## LINCOLN CITY/LANCASTER COUNTY PLANNING STAFF REPORT

-----  
for the May 28, 2003 PLANNING COMMISSION MEETING

**P.A.S.:** Change of Zone #3407 from R-2 to R-3  
Special Permit #2017 for a Community Unit Plan for 37 Dwelling Units

Maple Village CUP  
CZ#3407  
SP#2017

# MAPLE VILLAGE C.U.P. / SPECIAL PERMIT

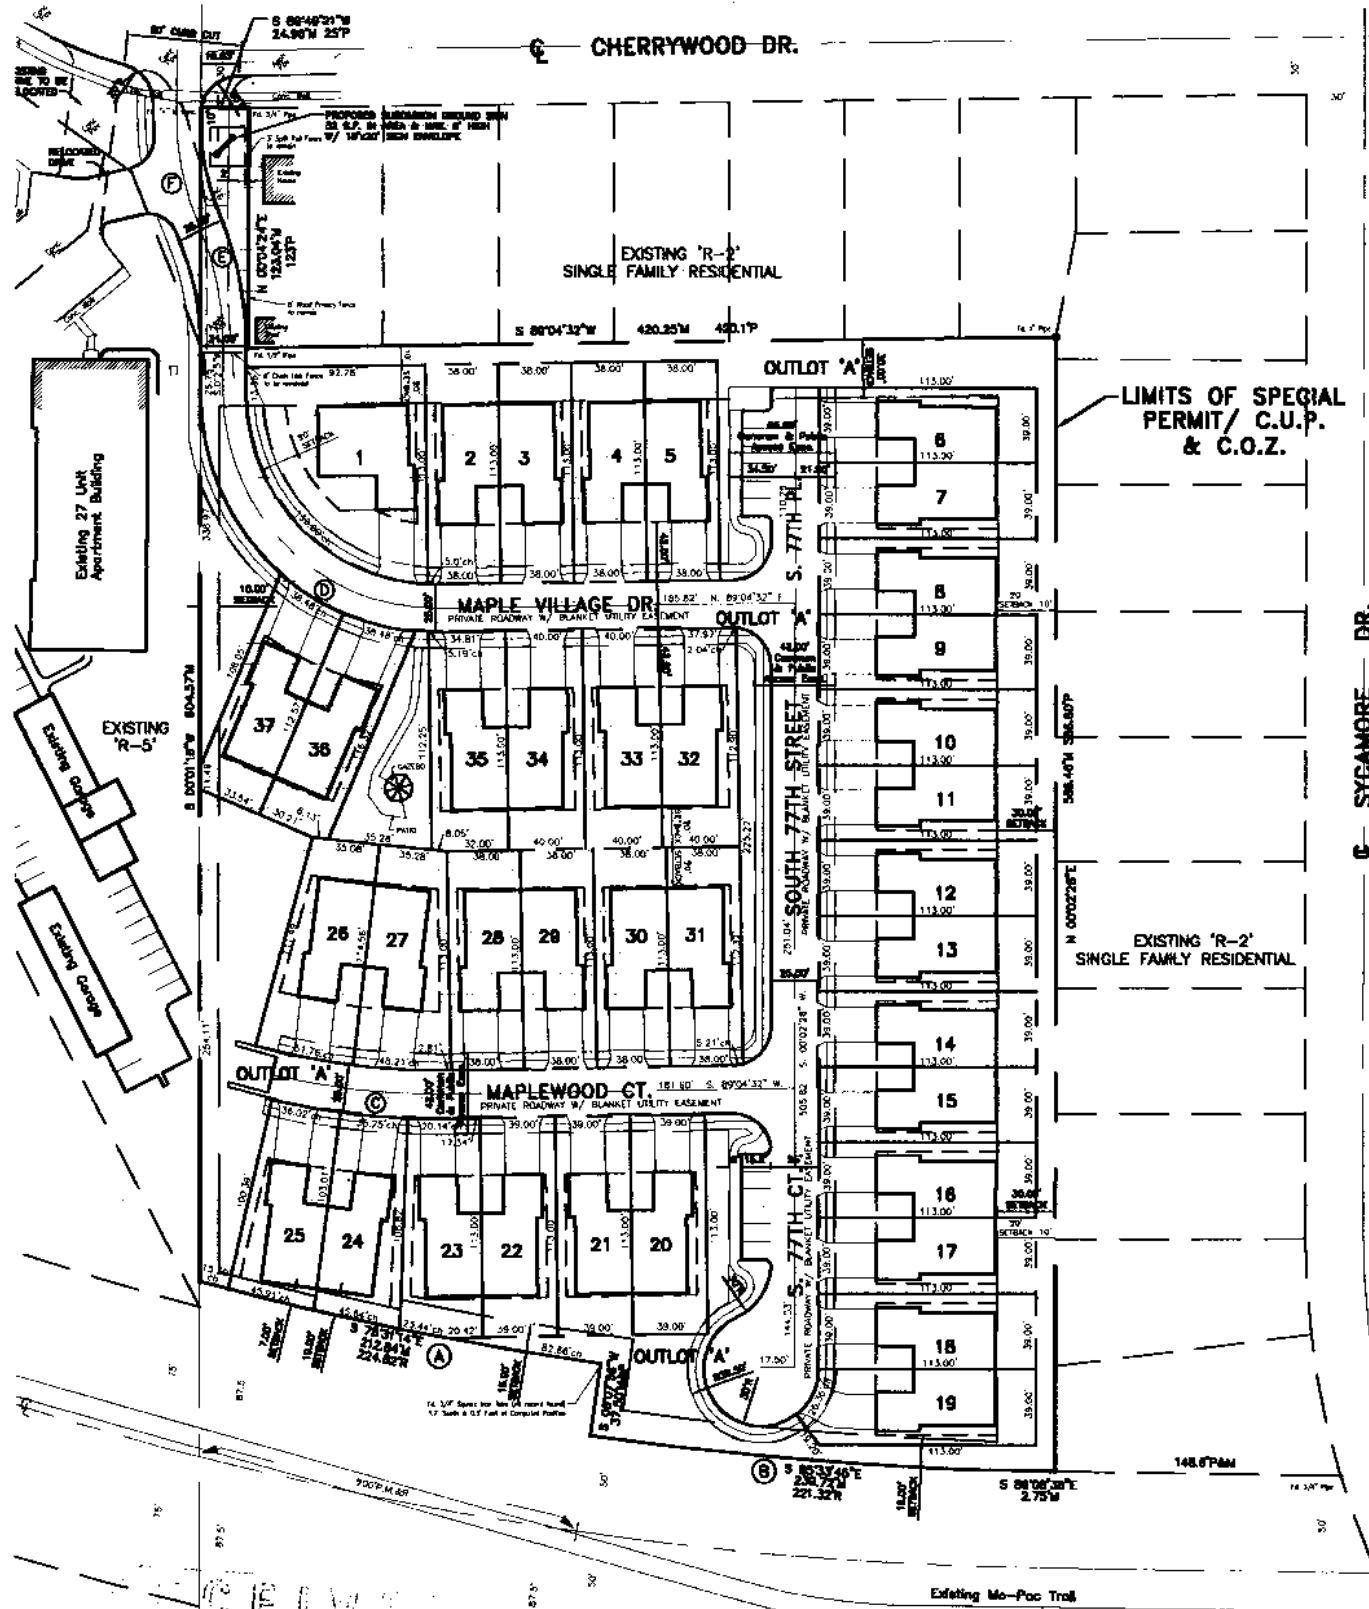
1. Access to the site is provided by a driveway off of Cherrywood Drive to be shared with the apartment complex to the west, and involves relocating the driveway of the apartment complex. This will require the improvements within the existing apartments to be modified to accommodate this change. The shared driveway is both encouraged and recommended, however, as proposed it does not allow for a sidewalk along the east side of the drive due to the proximity of the adjacent lot. The proposed design also requires waivers to design standards to allow the water main to run under the pavement, reduce tangent length between horizontal curves, and reduce the centerline radius of a private roadway.

2. A waiver to roadway width from 27' to 24' has been requested. Most of the private roadway system throughout the CUP is actually at 25', but it narrows to 24' near the entrance. Public Works notes in their review that a 27' wide roadway is the design standard and that it should be provided. Minimum roadway standards are established to ensure that reasonable accommodations are provided for vehicular traffic and emergency vehicle access and should be maintained.

It is also noted that turn-arounds are not provided at Maplewood Court or the north end of South 77<sup>th</sup> Place as required by the Subdivision Ordinance. To enhance traffic flow and to provide a second entrance, Maplewood Court should be extended to connect to the adjacent parking lot in the apartment complex. A turn-around should also be provided at the north end of South 77<sup>th</sup> Place.

3. The CUP includes 36 single-family attached units, and one detached single-family unit. The plan's density calculation indicates that 39 units are allowed. This calculation must be revised downward to accommodate the required 10% reduction per Design Standards and show a maximum density of 35 units. This will require the plan to be revised to show no more than 35 units. With this done, the plan will comply with the density requirements for a CUP in the R-3 district.

4. A waiver to the rear setback for all lots from 22.6' to 20' is requested, except for Lots 23, 23 and 25 where an additional reduction is requested. The request to waive the rear setback for all lots as shown is appropriate given that: the waiver for Lots 26-37 impacts only lots internal to the development; the rear lot line of the perimeter lots, Lots 1-19, is actually setback 10' from the CUP boundary resulting in a standard 30' setback from the neighboring lot's rear lot lines; and, Lots 20-25 are adjacent to the MoPac bike trail, a bike trail corridor that is approximately 175' wide at this point.

6. The landscape plan shows trees being removed along the south boundary of the CUP which helped provide a buffer between this site and the bike trail. Those trees being removed should be replaced with new ones planted along the south boundary to help preserve the buffer between the trail and the residences.

Additionally, the landscape schedule calls for planting Austrian Pine trees. These trees have recently been removed from the City's Approved Planting Schedule due to disease susceptibility. An alternate species must be substituted in the schedule.

8. One of the trade-offs associated with the higher density allowed in a CUP is the requirement for an outdoor recreation and open space plan. The plan shown does not include an active recreation component and must be revised. It is recommended the open area adjacent to Lot 25 be used for this purpose, and that a sidewalk connection to the open spaces between Lots 35 and 36 be provided.

9. The MoPac Trail is adjacent to the south and is a significant recreation opportunity for this development. A sidewalk connection from the South 77<sup>th</sup> Street cul-de-sac to the trail should be provided.

10. Other minor changes that must be made to the plan include: the southeast corner of Lot 20 encroaches into Outlot A; the surveyor's certificate must be signed; and, the project will need to use a name other than Maple Village as it has already been used in a previous subdivision.

- 1.1 Revise the site plan to show:
  - 1.1.1 Show a turn-around at the north end of South 77<sup>th</sup> Street.
  - 1.1.2 Maplewood Court extended to connect with the parking lot in the apartment complex.
  - 1.1.3 The roadway re-designed to the satisfaction of Public Works.
  - 1.1.4 Sidewalks along both sides of Maple Village Drive.
  - 1.1.5 Easements required by the May 9, 2003 LES review, including a blanket utility easement over Outlot A.
  - 1.1.6 Extend the sidewalk to the bike trail from South 77<sup>th</sup> Court.
  - 1.1.7 An outdoor recreation and open space plan approved by the Parks and Recreation Department including a sidewalk connection if required.
- 1.2 Revise the landscape plan to show:

- 1.2.1 An alternate species for Austrian Pine as noted in the Parks and Recreation Department's review.
  - 1.2.2 A note that states that all outlot areas to be maintained by the developer or homeowner's association.

- 1.2.3 The trees shown to be removed along the south part of the site being replaced or re-planted along the south boundary of the CUP.
  - 1.2.4 Planting method and a note that includes standard language concerning landscape material handling and planting being done consistent with City of Lincoln Design Standards.

# MAPLE VILLAGE C.U.P. / SPECIAL PERMIT

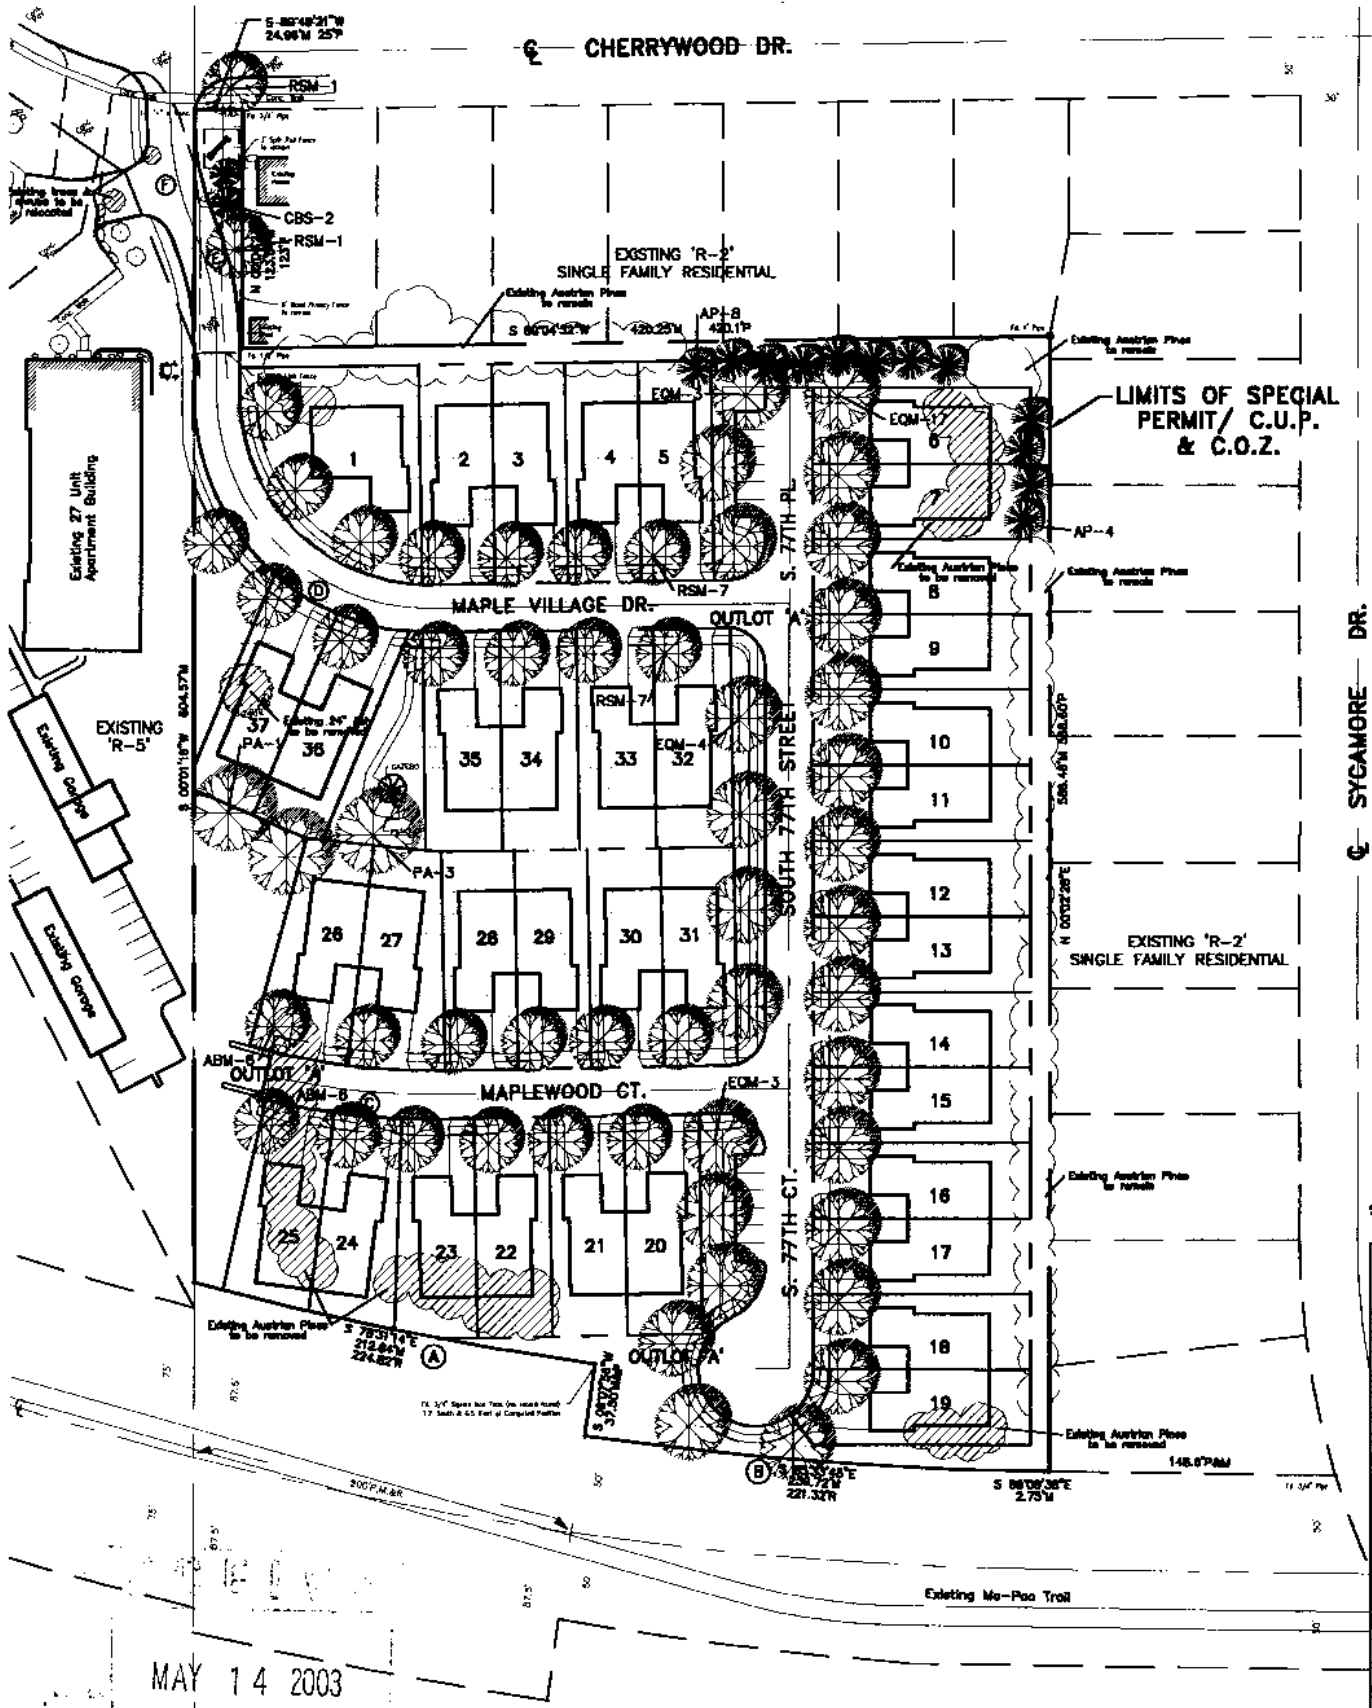
**Sanitary** - Show and label required sanitary sewer easements (minimum 30') for all proposed public sanitary sewer. Also show correct size for the existing sewer in the apartment complex to the west. The existing main is 18" not 8".

**Water** - Show and label required water main easements (minimum 30') for all proposed public water mains.

The water main south of Cherrywood Drive is located beneath the proposed paving and on the west side of the street, both contrary to design standards.

**Grading/Drainage** - A significantly larger area is proposed to drain to the northwest than as it exists today. There is no storm sewer proposed to capture any of the drainage to the northwest forcing the runoff into the street system and eventually to East O Street. Public Works recommends that storm sewer inlets be placed at the northwest end of Maple Village Drive and the drainage be piped down the west property line to the proposed detention cell. The detention calculations must be revised accordingly.

is Show the 100yr flood plain and flood way for Dead Mans Run which is adjacent to this plat. Also, it does not appear that consideration was made as to how the outlet structure will function in relation to tail water that will be generated in Dead Mans Run since the outlet is shown to be at the flow line of the channel. There is a 54" storm sewer that outlets into the channel upstream of the proposed outlet along with the outlet structure for Wedgewood Lake. The lake structure was not designed to retain additional water before water is released and subsequently there may be little delay in the release of flow from the lake in relation to the proposed project. This situation would cause water from the channel to back up into the proposed detention cell and the cell would not function for detention purposes.

An emergency over flow for the detention cell needs to be shown.

Streets - Design standards for private roadways state that a 27' wide roadway is required for all private roads that serve 30 or more parking spaces. All of Maple Village Drive and South 77th Street from Maple Village Drive to Maplewood Court is required to be 27' wide.

on This Maple Village Drive does not meet design standards for minimum tangent length for horizontal curves. A waiver needs to be requested for this exception to design standards. However, Public Works would not support this waiver. As shown the roadway is proposed to run next to an existing lot near the entrance to the development with the curb virtually the property line. This leaves no room for the required sidewalk, fence, or landscaping. is also the reason the water main is forced under the paving and on the opposite side of the street. It appears that the Maple Village Drive can be moved closer to the existing apartment building, away from the existing lot, and the entrance be reconfigured such that waivers for tangent length and curve radius standards are not required.

The proposed private roadway runs onto the adjacent apartment property. This property will need to be included in this special permit to approve the private roadway outside this development.

There are no turnarounds shown at the dead ends of Maplewood Court or 77th Place as per subdivision requirements.
